## DESCRIPTIVE REPORT

*Registry No.* ..... H11703

*General Locality* ..... Chatham Strait

*Sublocality* ..... North and South Arm Hood Bay

Figure 1 H11703 Area Surveyed

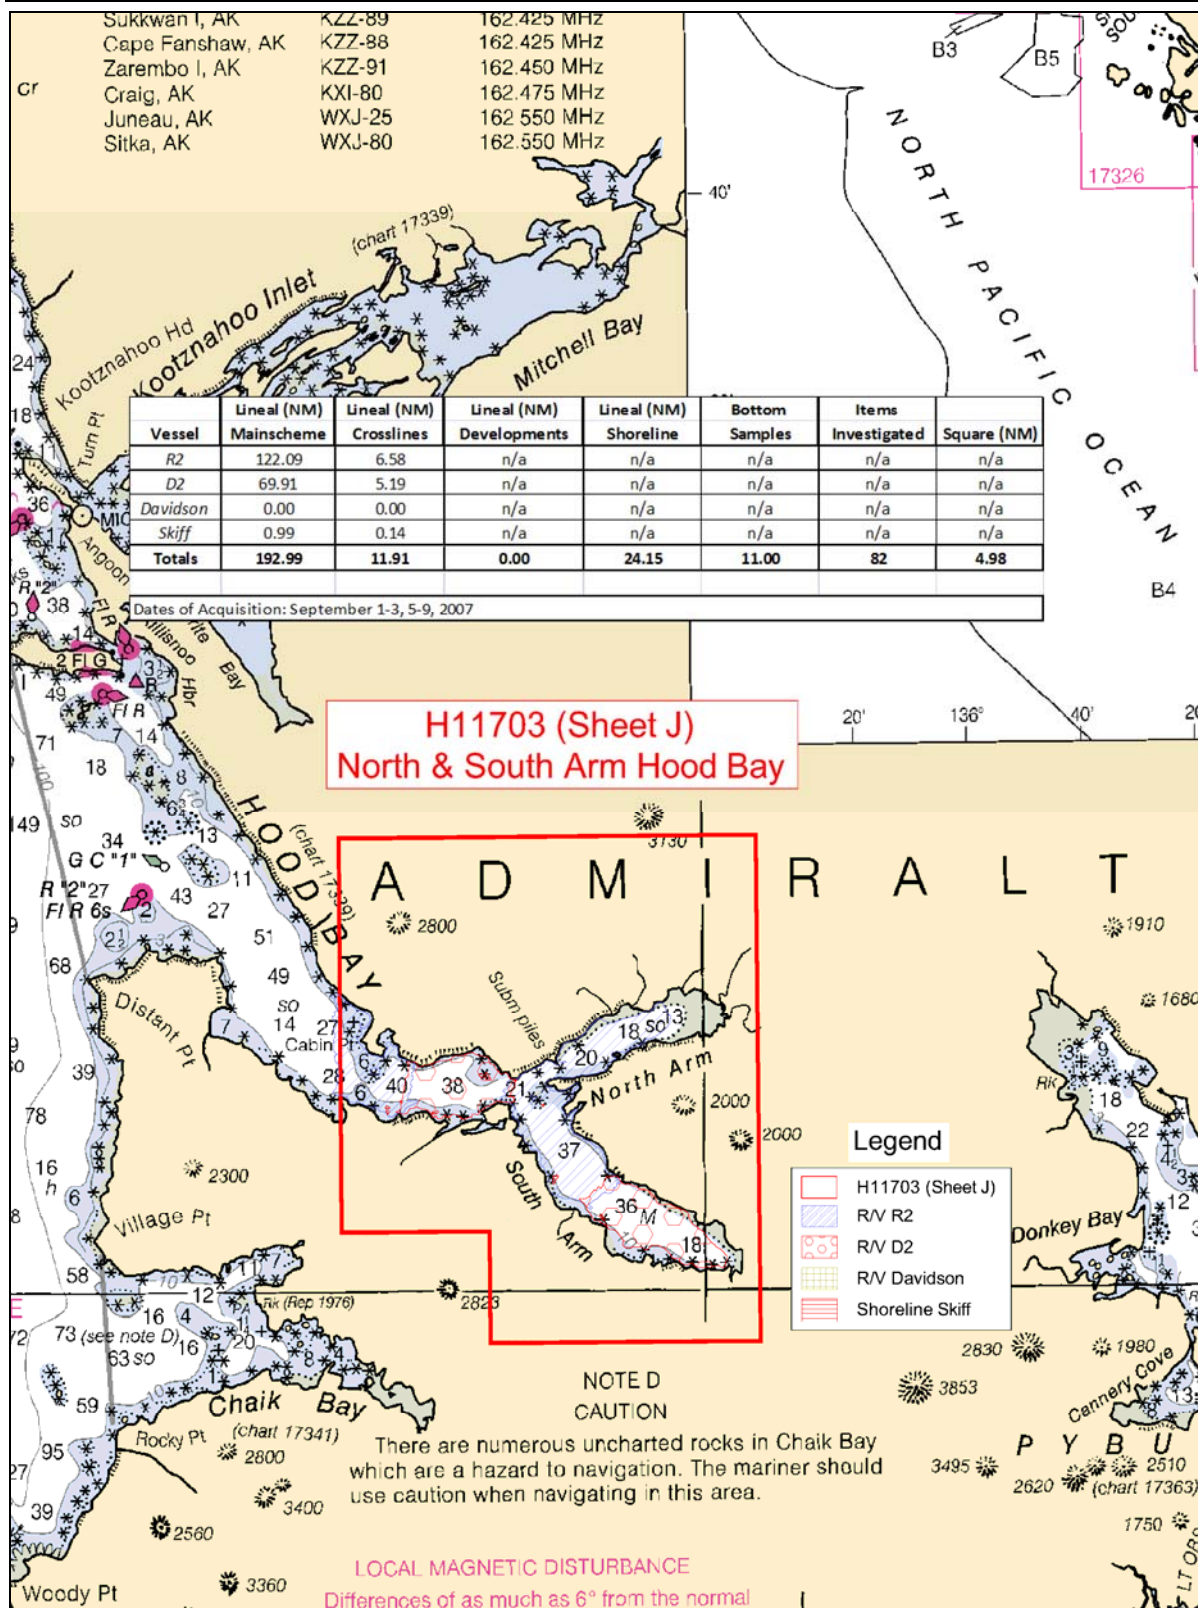
H11703 (Sheet J) is bound by the coordinates listed below, which encompass North and South Arm Hood Bay.

- <sup>1</sup> Do not concur. The bounding box of the survey has the following corners;  
SW – 57-20-12.282N, 134-29-02.019W NE – 57-23-54.692N, 134-19-02.603W

### Figure 5 H11703 Survey Junctions

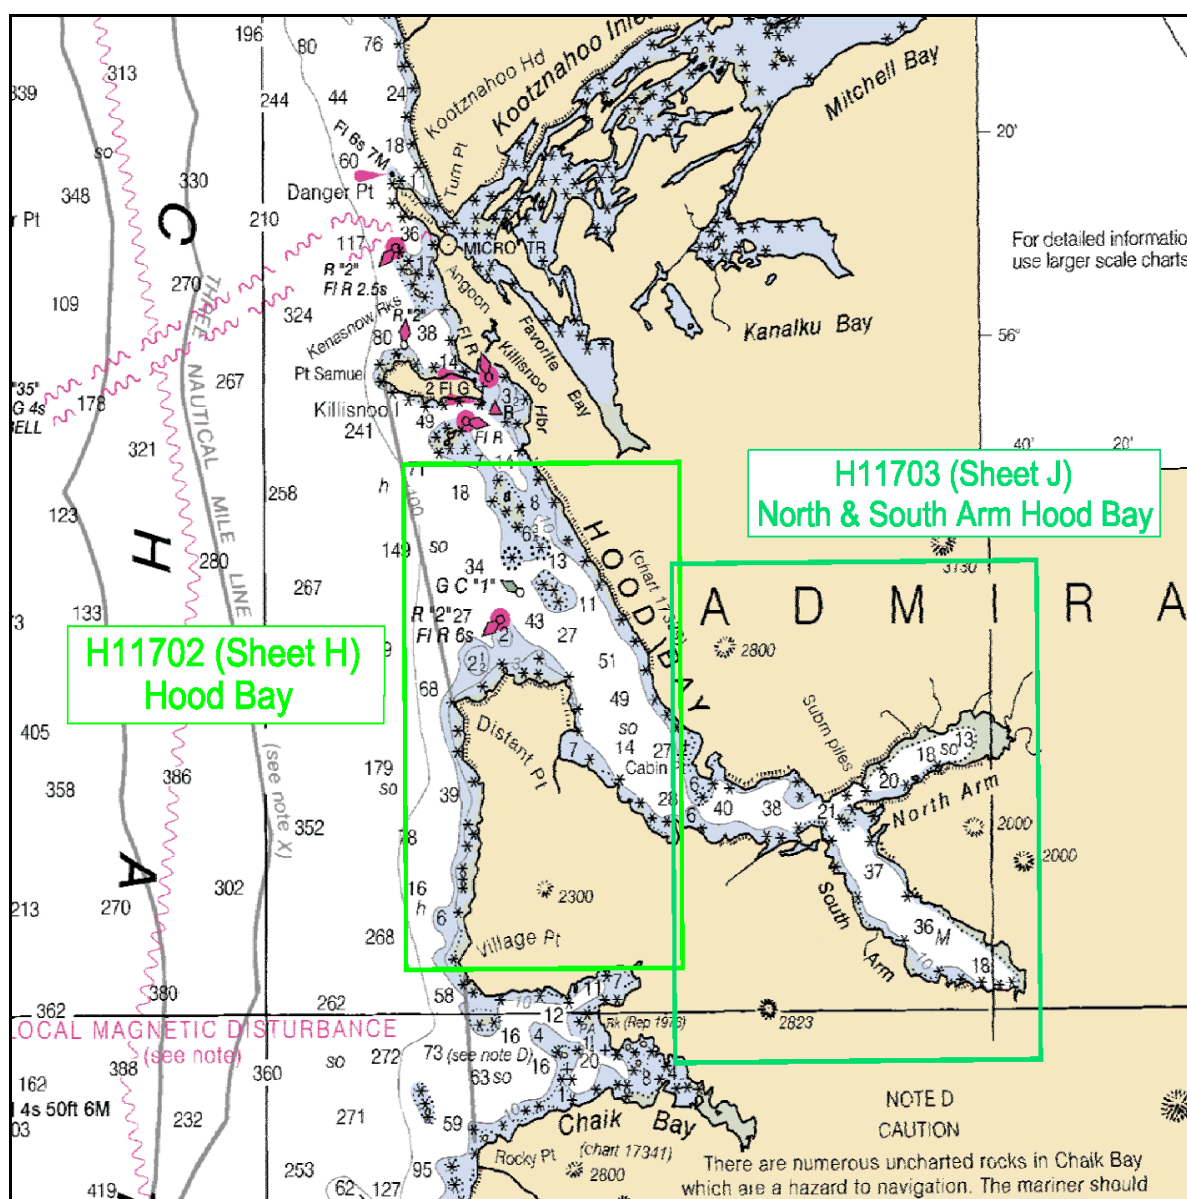
H11703 (Sheet J) junctions with: <sup>5</sup>

The surveys are in agreement along their common borders. The agreement was noted in the field using the CARIS CUBE surfaces during subset cleaning. The conformity is also apparent in the final combined BASE surfaces.<sup>6</sup>

- <sup>2</sup> Filed with project records.
- <sup>3</sup> Concur.
- <sup>4</sup> Concur.
- <sup>5</sup> During compilation, a junction was made with H11702 which has already been compiled and submitted.

- <sup>6</sup> Concur.
- <sup>7</sup> Concur.
- <sup>8</sup> Concur with clarification. A 5m combined surface was created during the Survey Acceptance Review and was the basis of compilation. See Survey Acceptance Review Checklist filed with hydrographic records.

**Figure 6 H11703 Chart Comparison 1 (Chart 17339)**

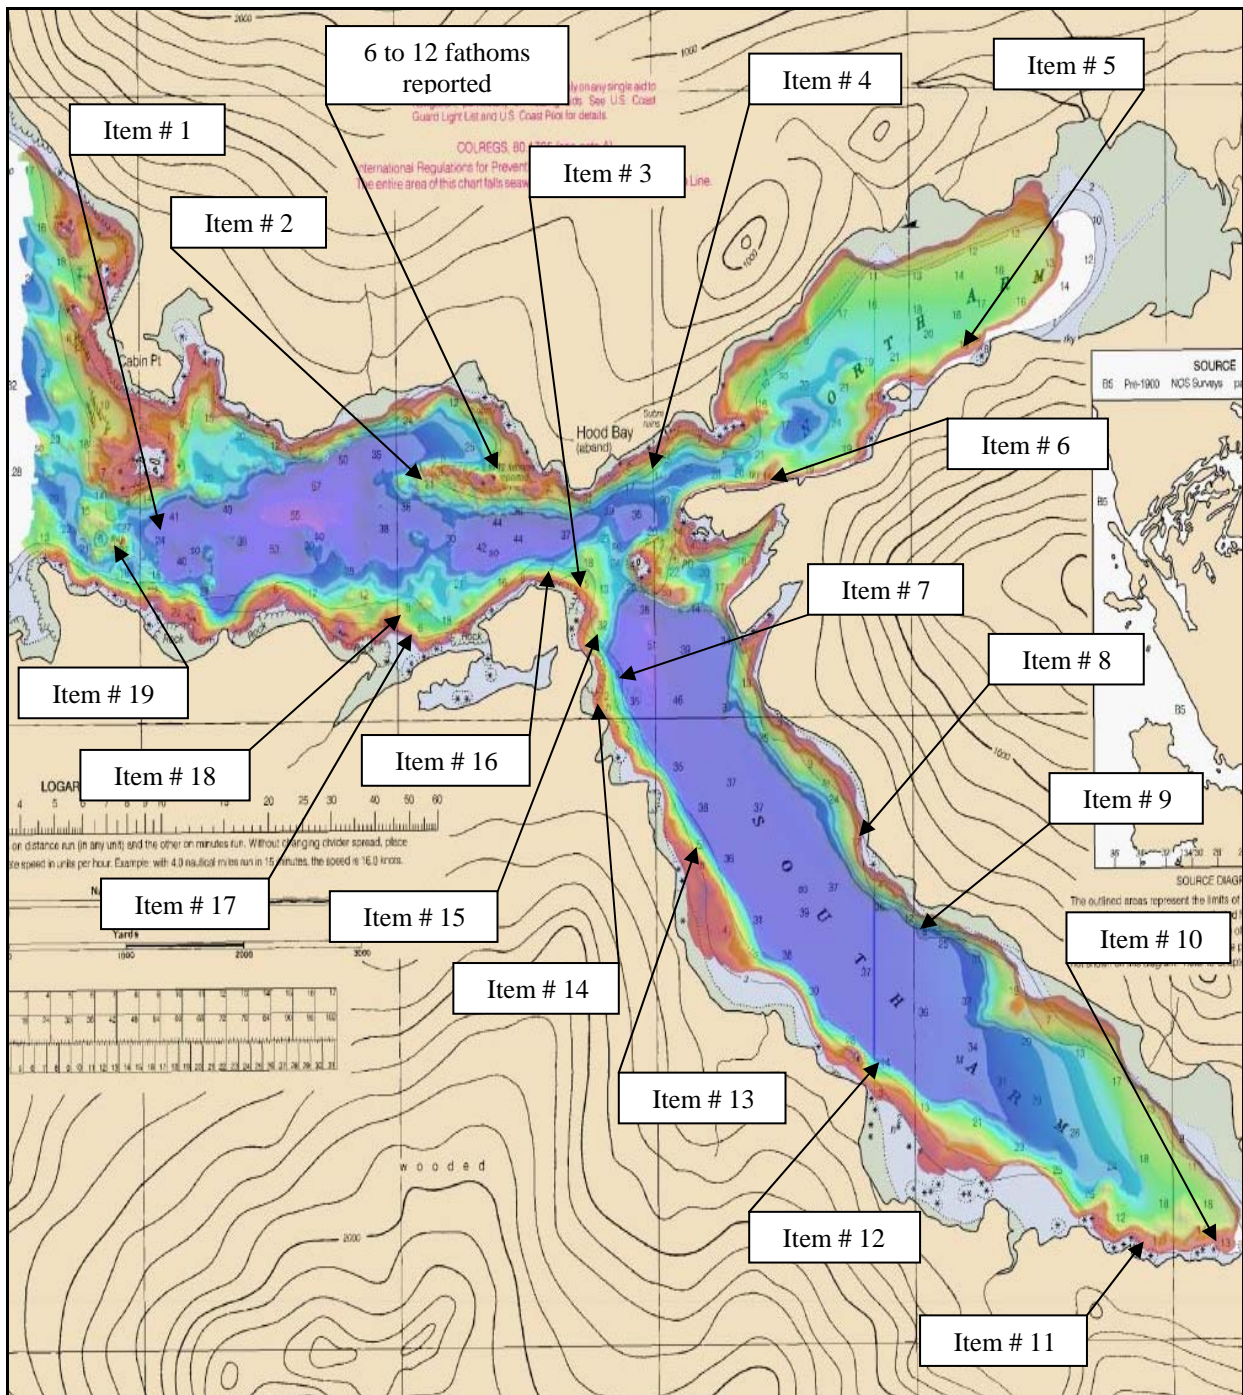
In general, the soundings from chart 17339 coincide with the soundings from H11703 to within 1 to 5 fathoms; areas that do vary to any degree are as follows:<sup>14</sup>

- 6 to 12 fathoms reported located at 57°22'49" N and 134°25'11" W; survey lines were conducted to provide 200% coverage over the area. The multibeam data was reviewed in CARIS HIPS and least depth of 7.5 fathoms (13.8 meters) was located.<sup>18</sup> It is noted above in Figure 6 H11703 Chart Comparison (Chart 17339).

- <sup>13</sup> Concur with clarification. ENC US3AK3UM covers the remaining portion of the survey area not covered by US3AK3BM.
- <sup>14</sup> Concur. Compiler agrees with field chart comparison. Supersede charted data in the common area.

- <sup>17</sup> Concur.
- <sup>18</sup> Concur with clarification. Update charts with survey depths and features included in the HCell.
- <sup>19</sup> Concur with clarification. Update charts with survey depths and features included in the HCell.

**Figure 7 H11703 Electronic Chart Comparison (Chart US3AK3BM)**

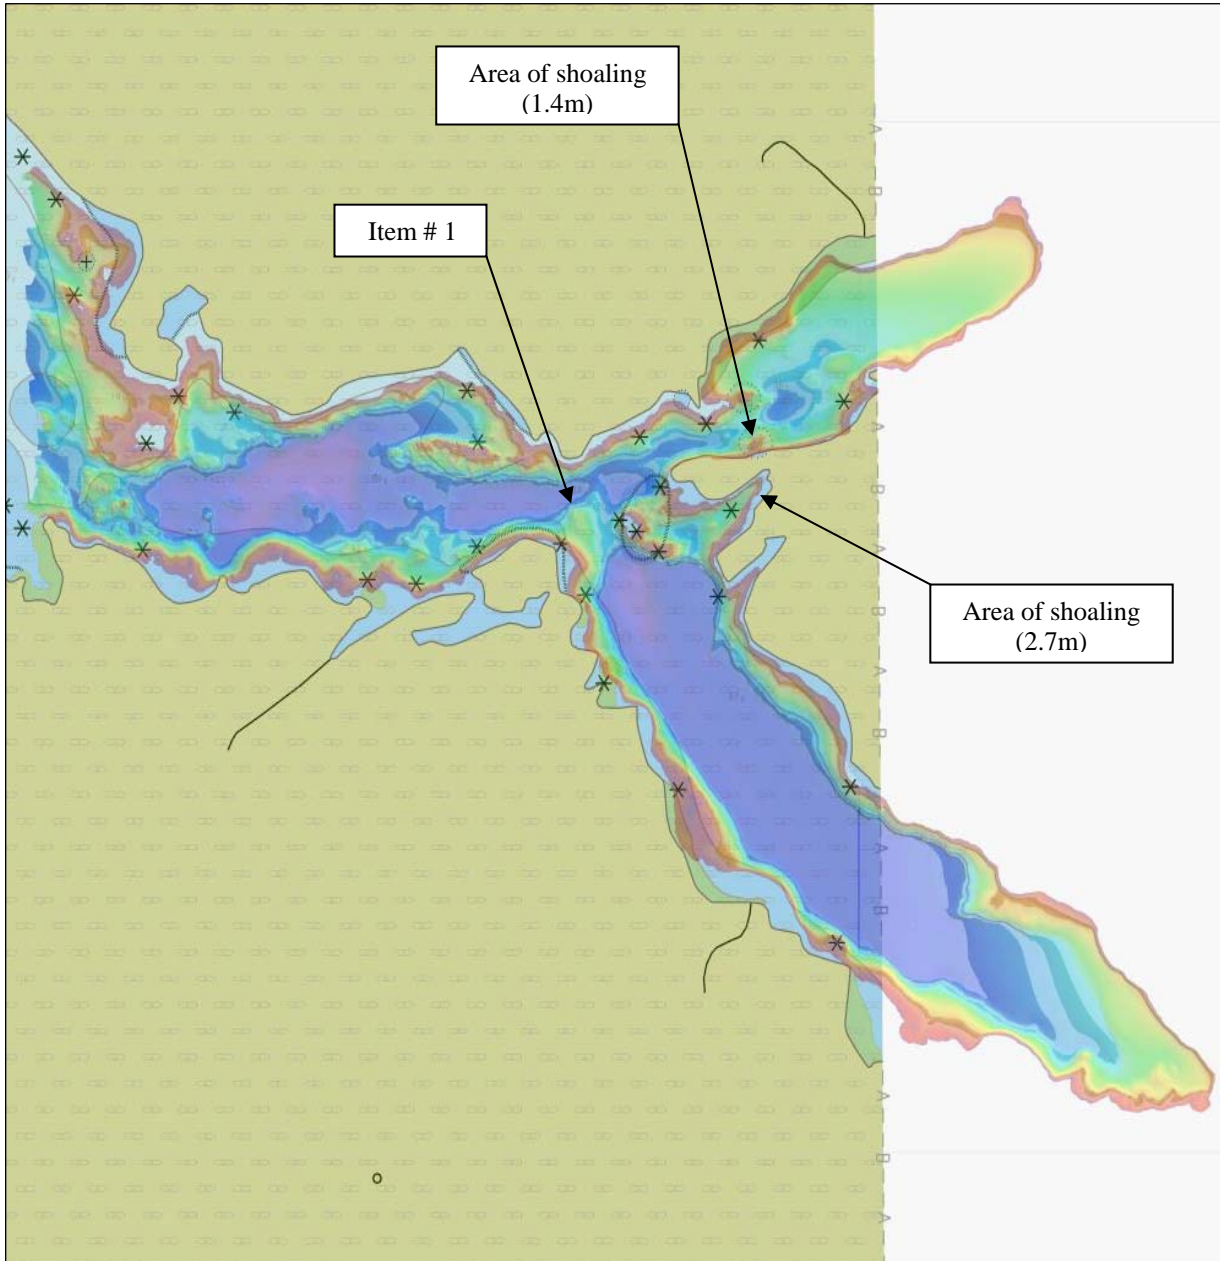
In general, the soundings from electronic chart US3AK3BM coincide with the soundings from H11703 to within 5 to 15 meters; areas that do vary to any degree are as follows:

- Electronic Chart US3AK3BM revealed an isolated 1.4 meter shoal located at 57°22'57" N and 134°23'10" W; survey lines were conducted to provide 200% coverage over the area. The multibeam data was reviewed in CARIS HIPS and the shoal was located with a least depth of 1.7 meters.<sup>19</sup> It is noted as "Area of Shoaling (1.4m)" in Figure 7 H11703 Electronic Chart Comparison (Chart US3AK3BM).

- Electronic Chart US3AK3BM revealed an isolated 2.7 meter shoal located at 57°22'47" N and 134°23'05" W; survey lines were conducted to provide 200% coverage over the area. The multibeam data was reviewed in CARIS HIPS and the shoal was located with a least depth of 2.9 meters.<sup>20</sup> It is noted as "Area of Shoaling (2.7m)" in Figure 7 H11703 Electronic Chart Comparison (Chart US3AK3BM).

- <sup>20</sup> Concur with clarification. Update charts with survey depths and features included in the HCell.
- <sup>21</sup> Concur with clarification. There were 16 DTONs reported from H11703. All 16 reported DTONs have been charted and all are included in the HCell.
